The City of Spartanburg Design Review Board

AGENDA

SUBJECT
DRB-Fifth Third Ballpark-300 West Henry Street

DATE
11/6/2023

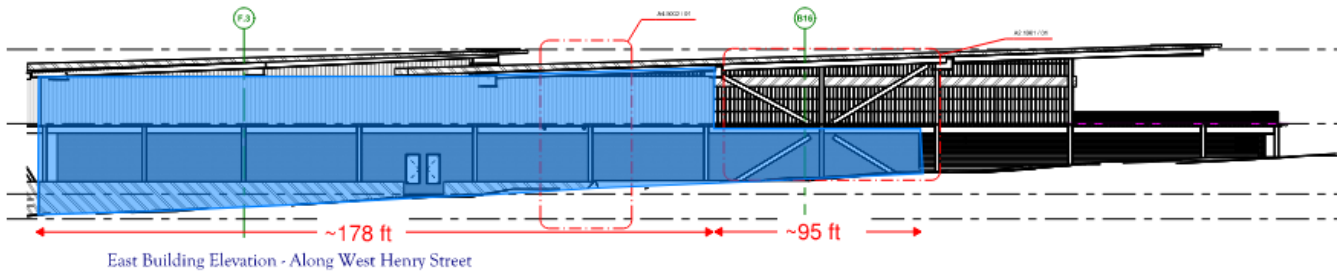
- **5.1.1 Lot Frontage:** All lots must front on a street, square, or common open space. ***Compliant***
- **5.1.2 Corner Lots:** Buildings located at street intersections must place the main building, or part of the building, at the corner. ***The primary corner is at West Henry and Daniel Morgan. It is presumed that the corner entry at the access road and West Henry is a function of the ballpark orientation.***
- **5.1.3 Pedestrian Entries from Frontage Line:** Buildings must have their principal pedestrian entrances on a frontage line. ***Compliant – primary entry is at the corner of West Henry and the Access Road***

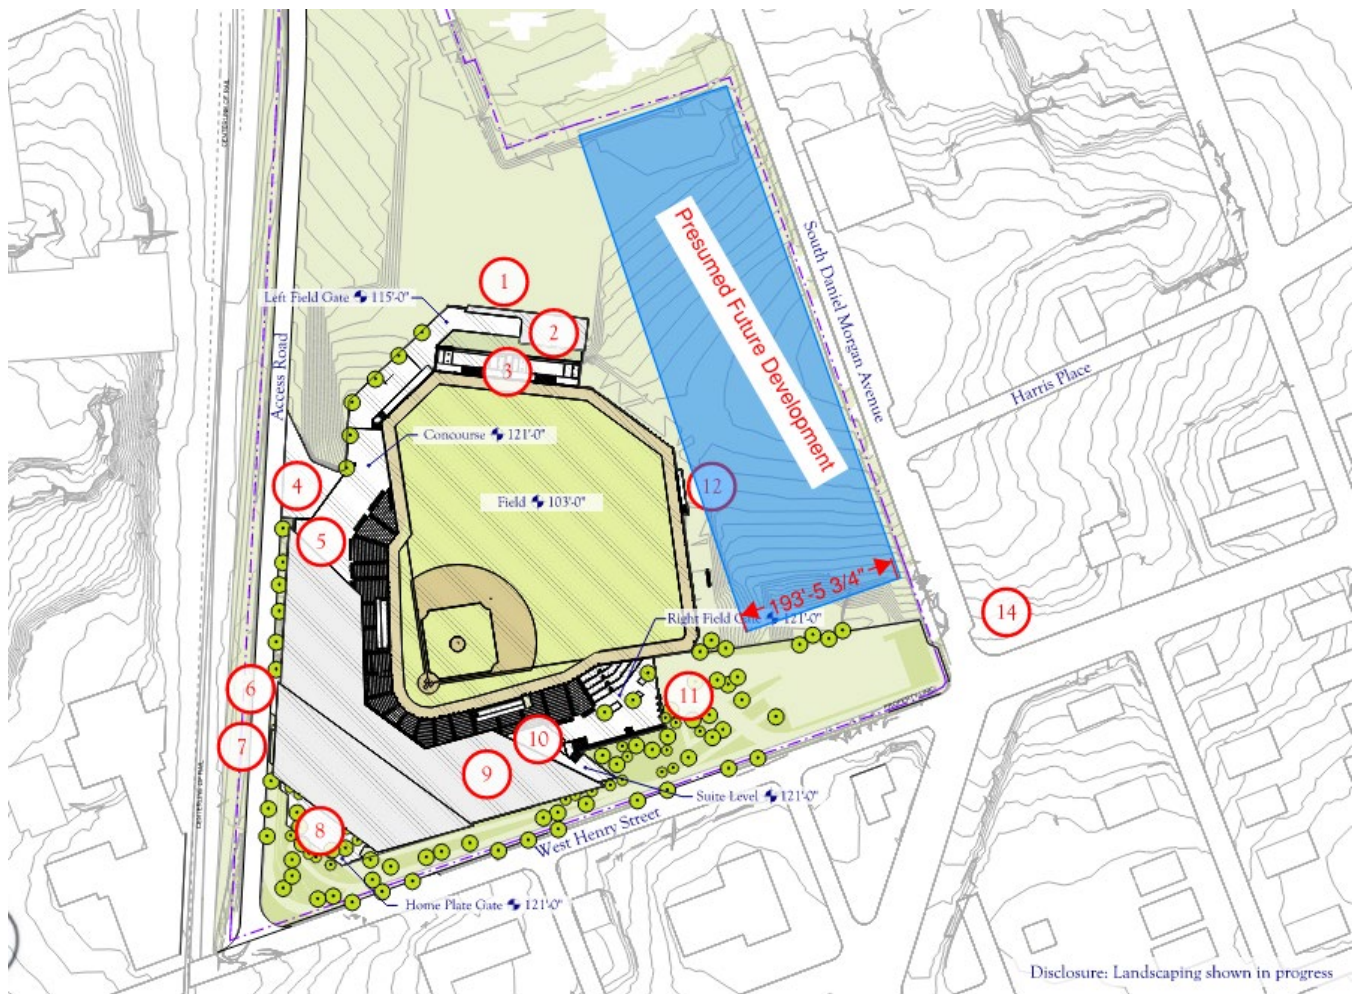
- **8.1 Required Streetscape:** 16 ft streetscape zone with a minimum 16 ft sidewalk and trees planted in wells consistent with downtown standards (40 ft on-center). *The proposed section does not show trees between the curb and the sidewalk. Sidewalk improvements are not shown along Daniel Morgan. Please adjust the plans accordingly.*

- **Substandard Streetscape along Henry Street and Daniel Morgan Avenue Street:** The proposed section does not show street trees, nor does it indicate the treatment of Daniel Morgan. Given the expectation of foot traffic along Daniel Morgan, the current condition needs to be improved along both streets. Street trees should be shown in 6 foot planters strip between the sidewalk and the curb.
